# Release note

## Product : MD330U/MD330UI

<b>FW version</b>	<b>1.1.1041.0</b>
Release date	2024/3/5
New feature	<p>1. <b>Support <a href="#">EPIC ECAL</a></b></p> <p>Camera IP URL for EPIC system would be <a href="https://ip/html/ecal.html">https://ip/html/ecal.html</a></p> <p>Based on the requirements of EPIC ECAL, we have preset an HTTPS certificate in the device and strongly recommend that customers replace HTTPS certificate with their own when using</p> 
Improvement	<p>1. <b>Improve Eyes Tracking</b></p> <p>Fix the tracking issue that occurs in Eyes Tracking under certain conditions.</p> <p>2. <b>Optimize UX on Web UI</b></p> <p>Buttons on the web interface will have color feedback when pressed.</p>

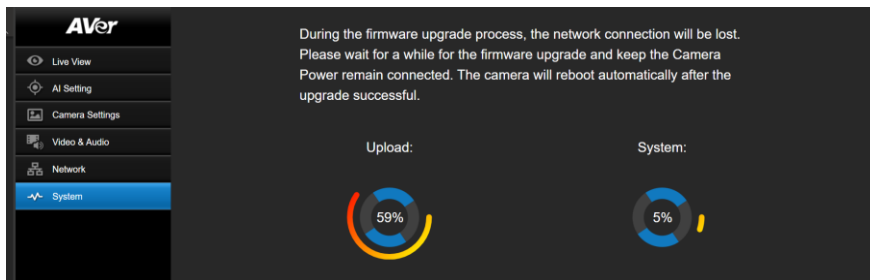
3. **Improve auto focus in handhold mode**

Now, slight hand shaking will not trigger refocusing, which greatly reduce the AF hunting.

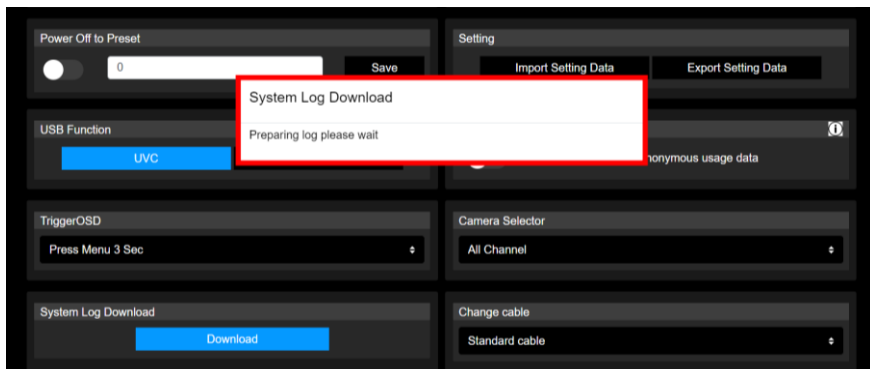
4. **Optimize the firmware update UI**

You can now clearly see the current progress of the update.

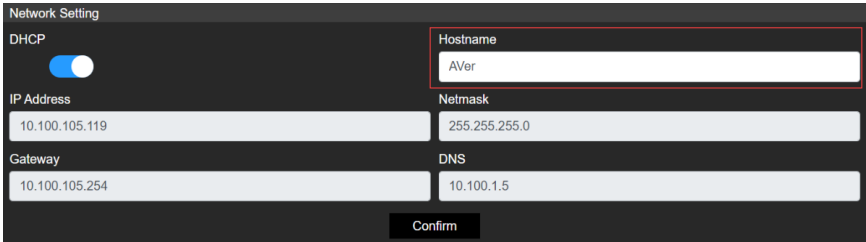
5. **Optimize user flow when download log**

A prompt window will pop up when the UI is temporarily frozen due to downloading logs.
